**EARLY CHILDHOOD CENTER AT
TWO RIVERS SCHOOL
Snoqualmie Valley School District**

ADDENDUM NO. 4

Addendum no. 4 is hereby made a part of the Contract Documents for the EARLY CHILDHOOD CENTER AT TWO RIVERS SCHOOL Project, located in North Bend, for Snoqualmie Valley School District.

Sheet A6.01 – REFLECTED CEILING PLAN

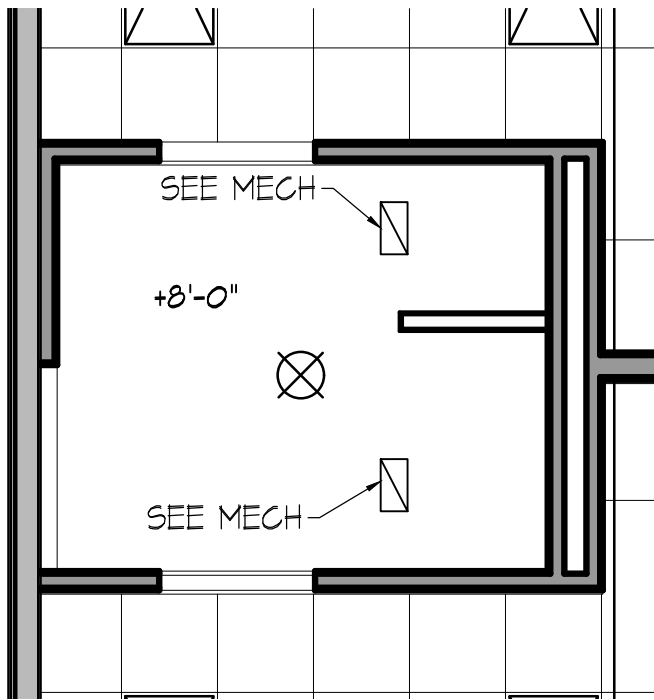
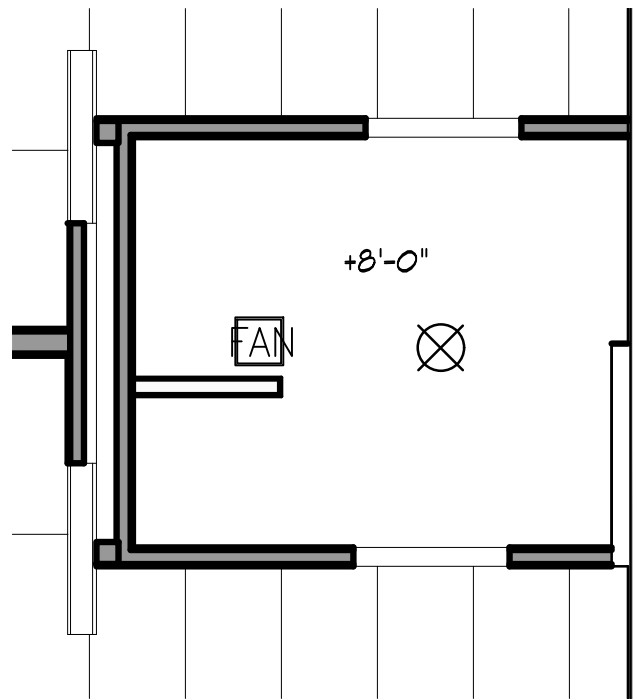
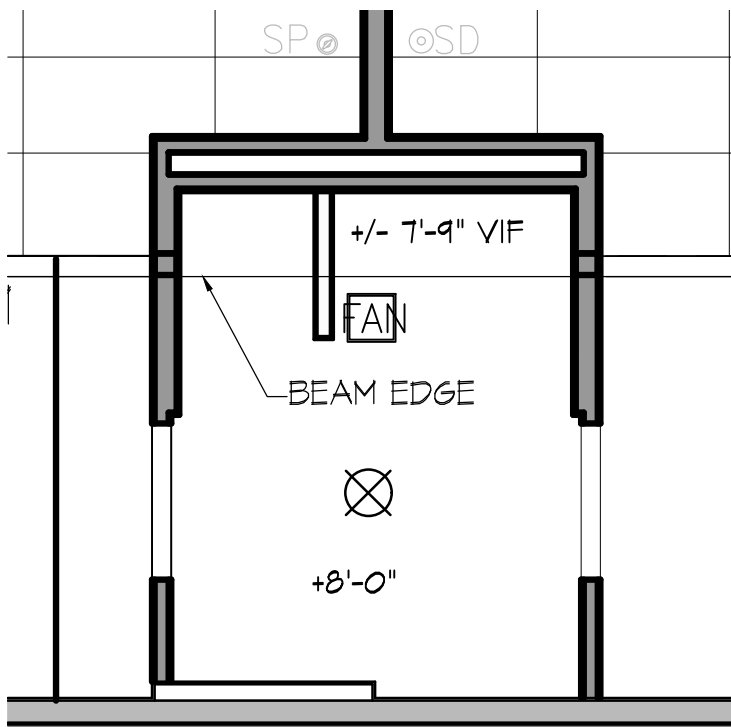
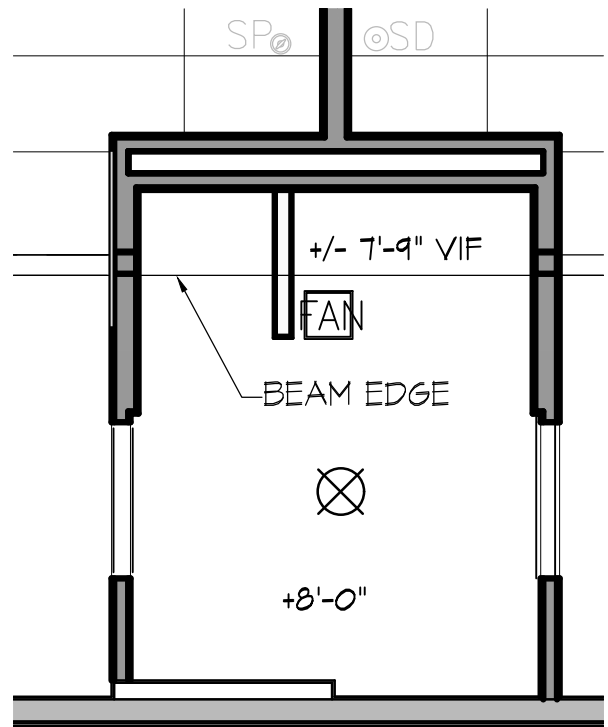
Item 1 Contractor Question: *The RCP on A6.01 shows ACT in the restrooms. Per section cut 3/A3.11 it calls for GWB through the shared restroom 131. Please clarify if this restroom gets ACT or GWB. Are the other restrooms GWB or ACT?*

- Item 14 Ceilings in toilet rooms 128, 131, 135 and 137,(shared toilet rooms between classrooms) are to be finished 5/8 GWB. See addendum drawing SA-03 for additional clarification. (Attached)

Answer: It is the intent to do hard ceilings (5/8" GWB) in these 4 toilet rooms. See below for other changes in the addendum to address this.

Sheet M2.01 – ENLARGED MECHANICAL PLANS (revised sheet attached)

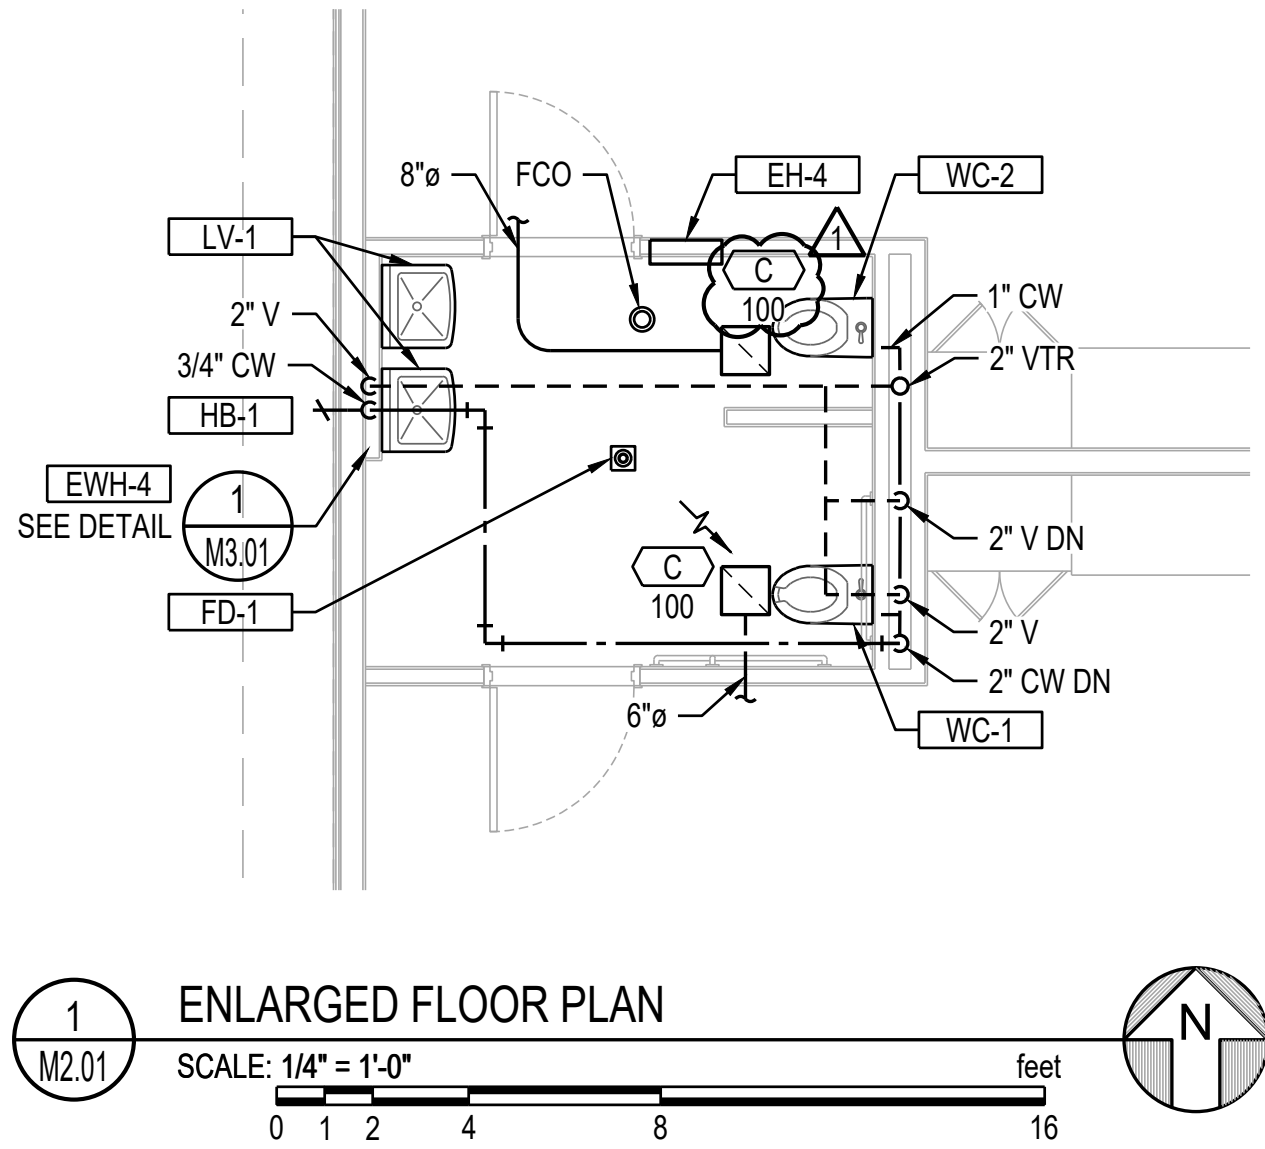
- Item 16 ADD the Energy Recovery Ventilator Schedule as shown on the attached sheet.
- Item 17 ADD the Electric Heater Schedule as shown on the attached sheet.
- Item 18 ADD the Exhaust Fan Schedule as shown on the attached sheet
- See Attached REVISED Sheet M2.01 – ENLARGED MECHANICAL PLANS
